# WHMD RWRF STORMWATER IMPROVEMENTS

## El Paso County, Colorado

CDR268

The purpose of this **Final Drainage Letter ("FDL")** is to document the proposed improvements to the drainage design to the Woodmen Hills Metropolitan District Regional Water Reclamation Facility ("WHMD RWRF"). The Project is located within the jurisdictional limits of El Paso County ("the County"). Therefore, the hydrologic and hydraulic design is based on the County's criteria which is described in further detail within the report.

# WHMD RWRF Stormwater Improvements StormCAD Map

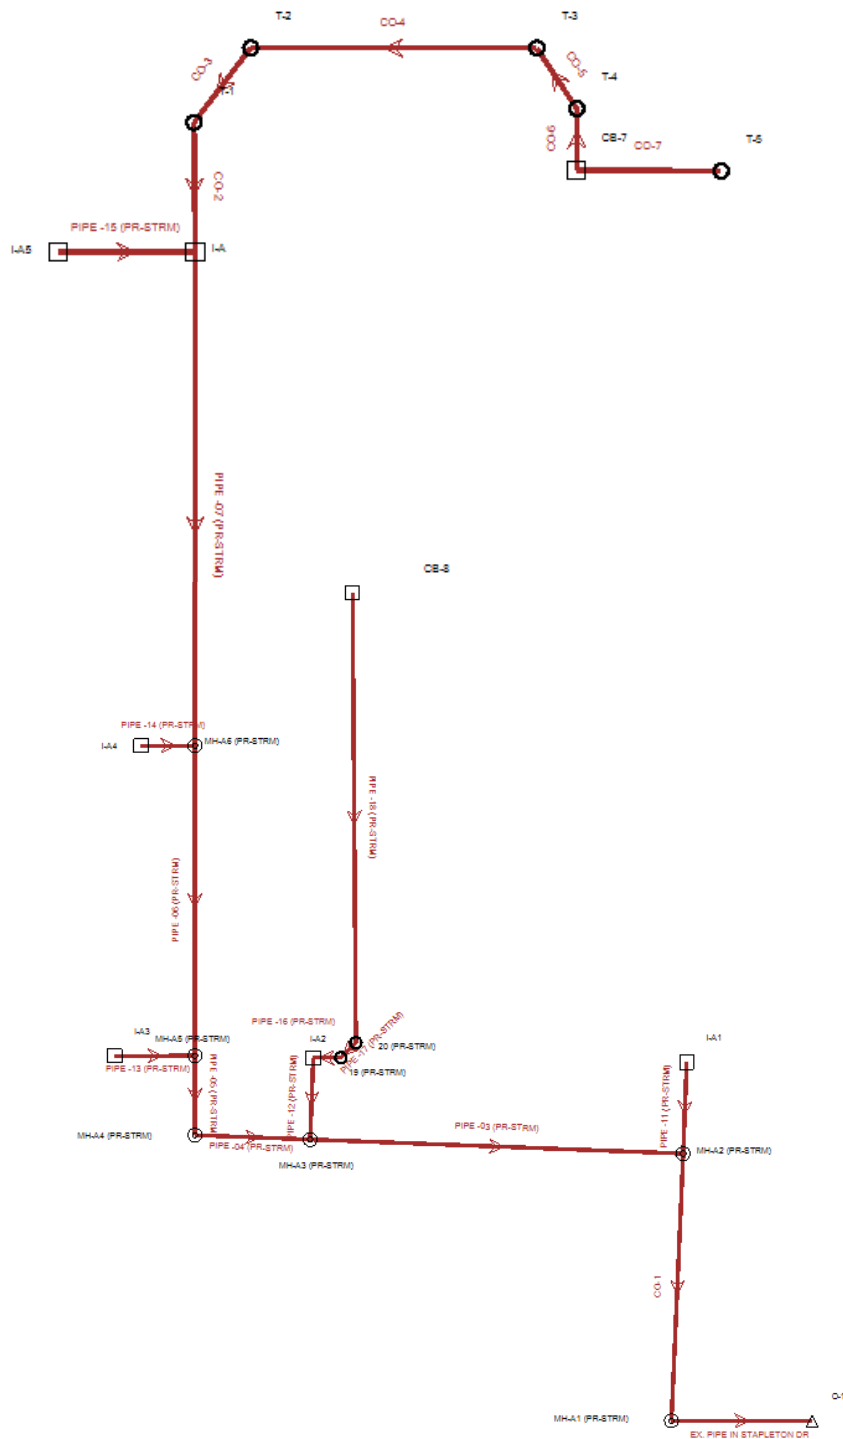
Is it possible to include a higher resolution image of this schematic...it is a little hard to read.
